TECHNICAL EVALUATION REPORT FOR DIRECT
GENERATION OF FLOOR SPECTRUM FOR LONG TERM
SERVICE SEISMIC REEVALUATION: SAN ONOFRE
NUCLEAR GENERATING STATION UNIT 1

June 1985

SAN ONOFRE NUCLEAR GENERATING STATION UNIT 1

Fig. 2

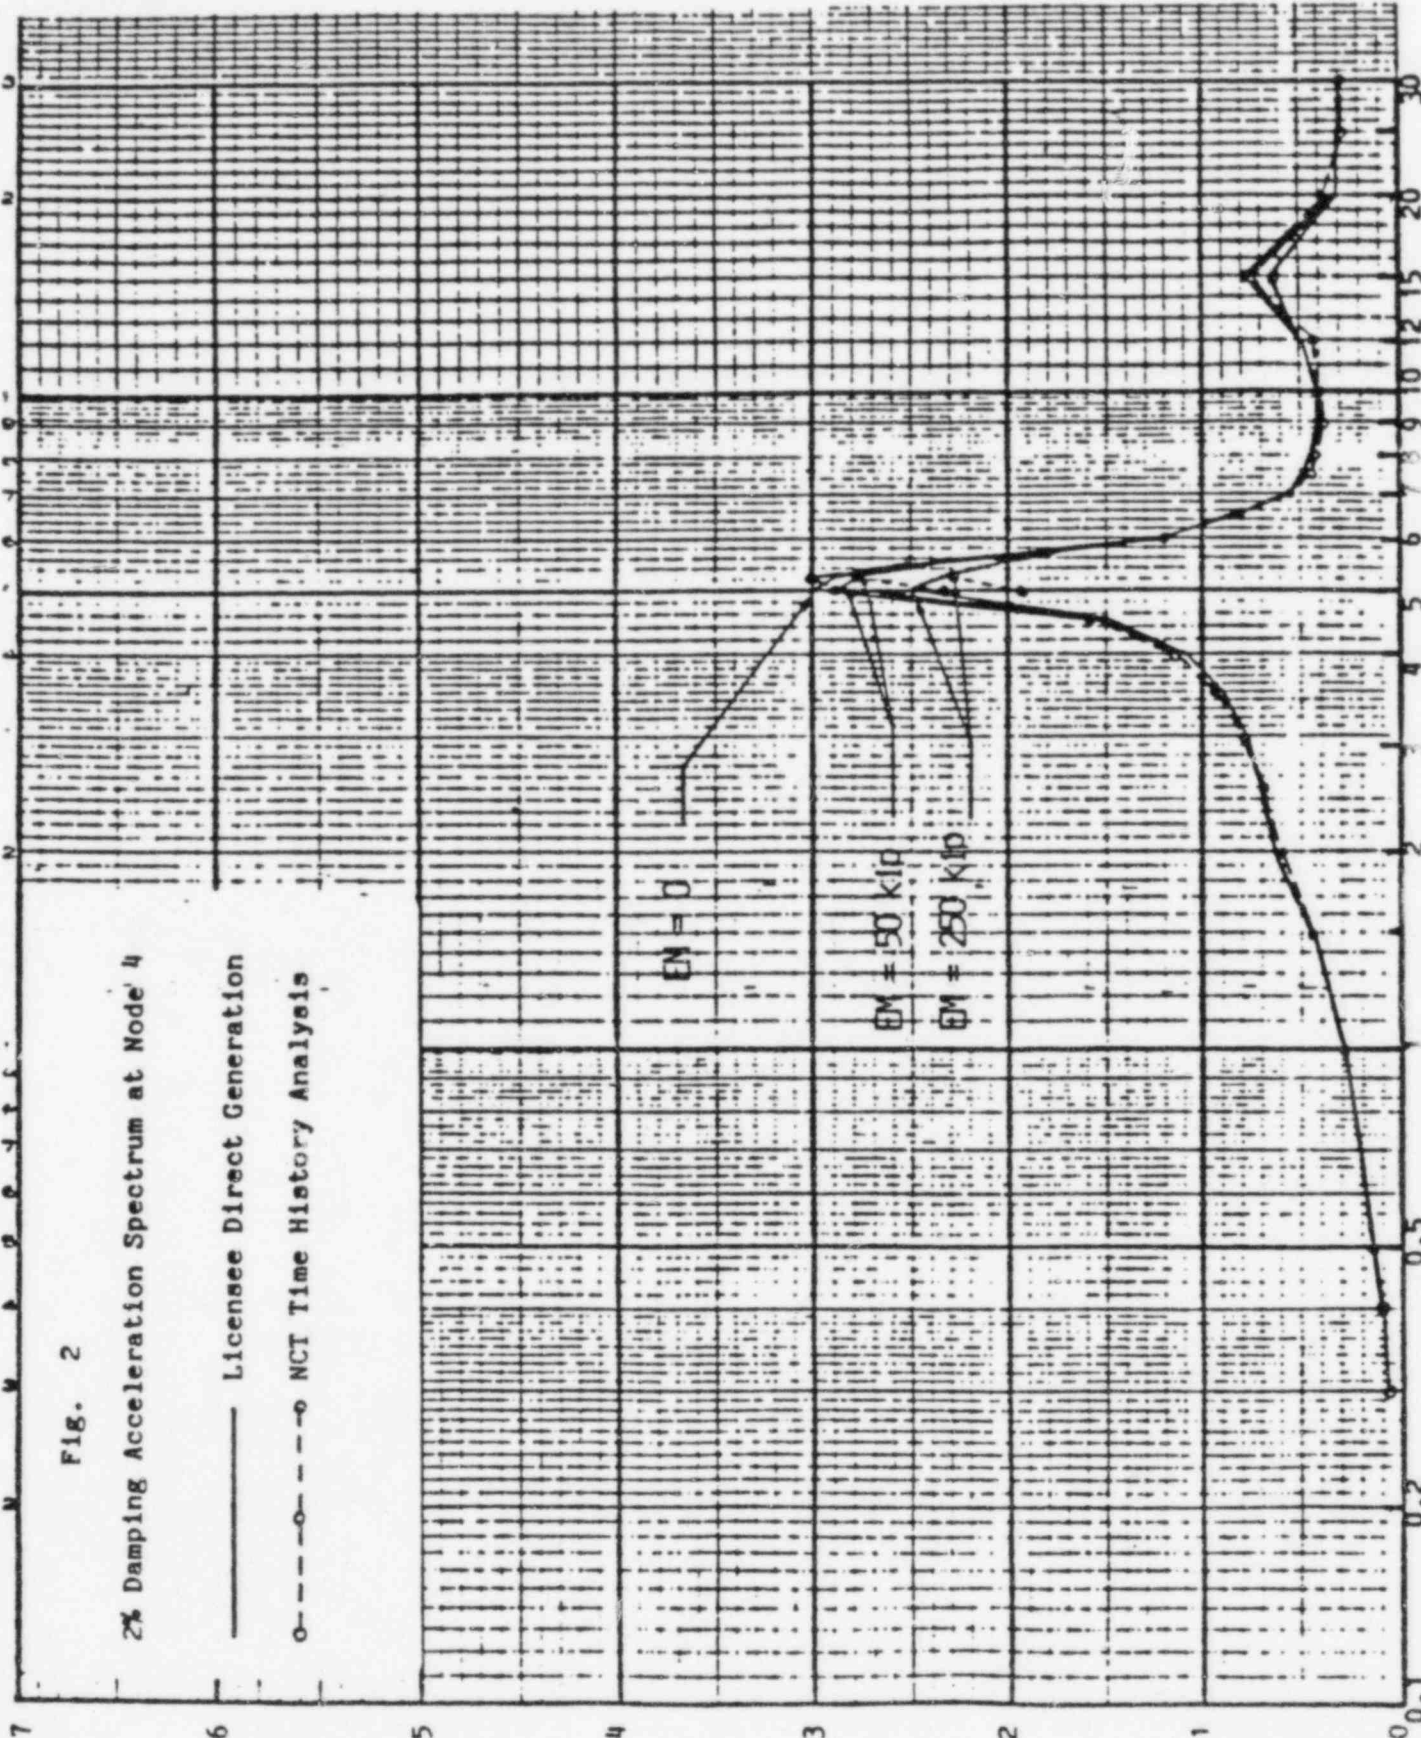
Figures 2 and 3 compare the FLORA generated floor response spectra with the corresponding time history analysis results. For EM=50 and 250 kips, the time history solution was calculated only at three frequencies, namely, 5.00, 5.26 and 16.2 Hz, because the spectrum is not as sensitive to the value of EM at frequencies other than the dominant structure frequencies as evidenced in Figs. 2 and 3. For the dominant spectrum peak around the first structure mode, the licensee solutions (Ref. 7) do not always occur at the same frequency as the time history solution. The slight discrepancy in peak frequency, however, is immaterial in applications due to the fact that the spectrum peaks must be broadened prior to piping analysis. Therefore, it is sufficient to compare the spectrum peak values between the two solutions. For the dominant spectrum peak, the FLORA solution based on the wide-band technique differs from the time history solution by 3%, -1% and -1% for EM=0, 50 and 250 kips, respectively, at Node 11, and by 0%, 5%, and 8% at Node 4.

In other words, for EM=0, the FLORA spectrum is in close agreement with the time history solution throughout the entire frequency range. For non-zero EM values, the FLORA solution is, on the average, slightly more conservative than the time history solution.

Based on our review of the theory and the results from the test problem, we conclude that the FLORA direct spectrum generation, including the effect of secondary mass coupling, is sufficient for applications to the SONGS 1 LTS seismic reevaluation provided that the wide-band solution technique in FLORA is used.
